# Access Compliance Report

## Public Rights-of-Way

### (Curb Ramps)

Intersection ID: 4700	Main Street: BELLA_VISTA_CT	Cross Street: FREE_BIRD_AV	Location: SW
ADA ID: 141E11F3ACAC	Ramp Type: Perp	Initial Pass/Fail: Fail	Overall Compliance: No
Severity Score: 36.25			
Codes/Mitigation Info/Possible Solution		Field Measurements/Component Compliance

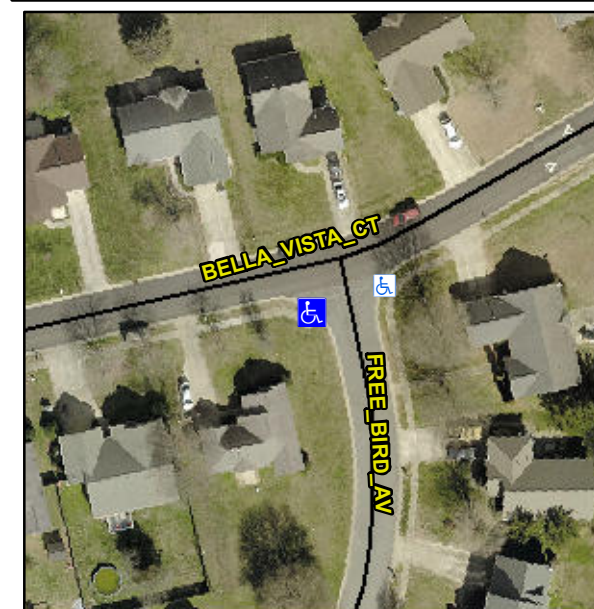
**Not Found, R304.5.1, R304.5.3**

Compliance	Description	Data	Compliance	Description	Data
N/A	Ramp Length (in)	48.0	Yes	Ramp Slope (%)	5.7
No	Ramp Width (in)	30.0	No	Ramp XSlope (%)	4.6
N/A	Flare Type LT	N/A	N/A	Flare Type RT	N/A
N/A	Flare Slope LT (%)	N/A	N/A	Flare Slope RT (%)	N/A
N/A	Flare Traversable LT?	N/A	N/A	Flare Traversable RT?	N/A
N/A	Landing Length (in)	N/A	N/A	DWS Provided?	N/A
N/A	Landing Width (in)	N/A	N/A	DWS Contrast?	N/A
N/A	Landing Slope (%)	N/A	N/A	DWS Length (in)	N/A
N/A	Landing X Slope (%)	N/A	N/A	DWS Full Width?	N/A
N/A	Landing Curb? (Y/N)	N/A	N/A	DWS Offset (in)	N/A
N/A	Shared Landing?	N/A			
N/A	Gutter Ponding?	N/A	N/A	Gutter Slope (%)	N/A
N/A	Gutter Lip Ht (in)	N/A	N/A	Gutter X Slope (%)	N/A
N/A	Painted X Walk1?	No	N/A	Painted X Walk2?	N/A
	X Walk 1 Direction	To E		X Walk 2 Direction	N/A
N/A	X Walk 1 Width (in)	N/A	N/A	X Walk 2 Width (in)	N/A
	X Walk 1 Slope (%)	1.5		X Walk 2 Slope (%)	N/A
	X Walk 1 X Slope (%)	3.1		X Walk 2 X Slope (%)	N/A

**Remove & Replace Entire Ramp.**
